**1 Products affected**

Product Change Notification					PCN TTS Connector		
owner	creation date	release date	released by	change order no	rev	page	D10-063-881
rescalfa	29.04.2022	02.05.2022	riedlan	2023971	B	1 of 2

Current product appearance	New product appearance

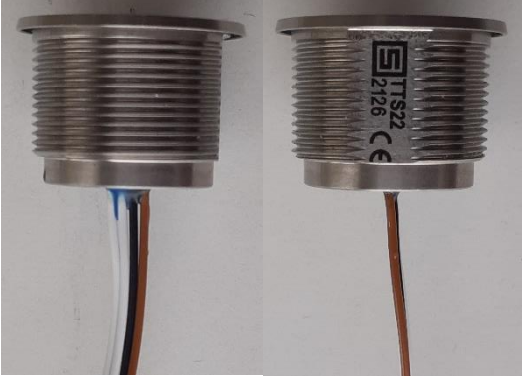
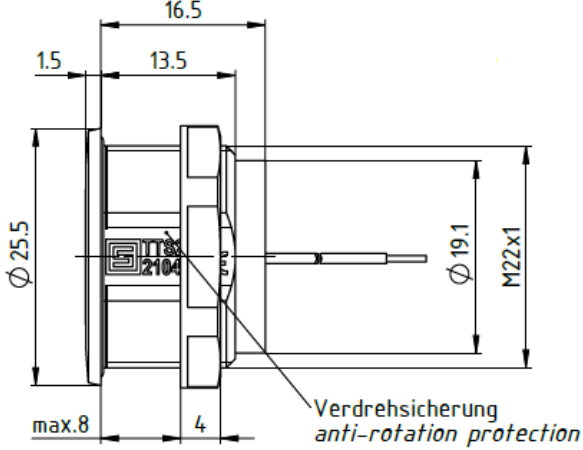
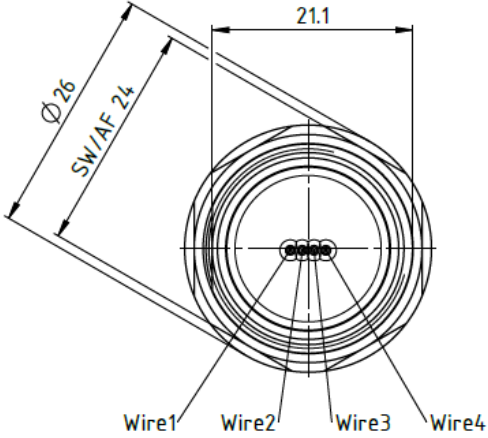
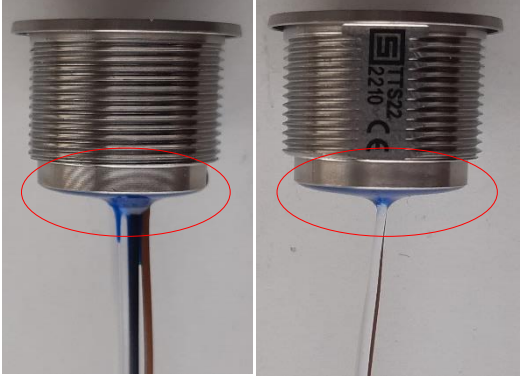
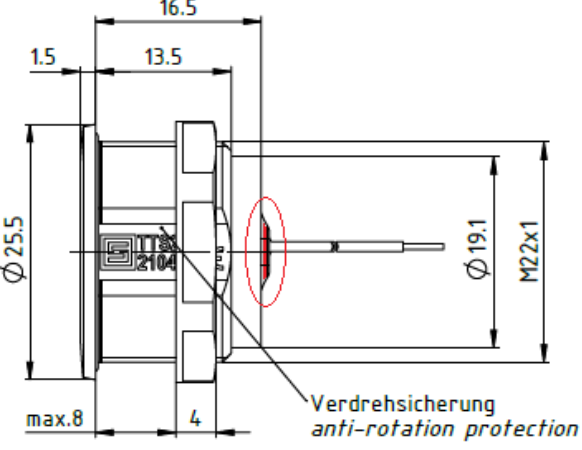
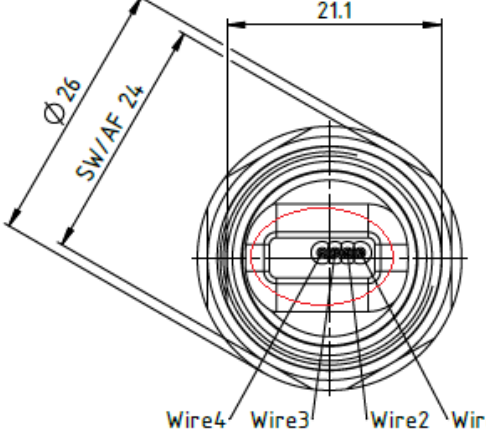
- Change of internal connector

- Change due to the implementation of a multicolour (RGB) variant.

- Form                      Check for any effects on the mounting situation
- Fit                              Check for any effects on the mounting situation
- Function
- Manufacturing
- Label
- Packaging
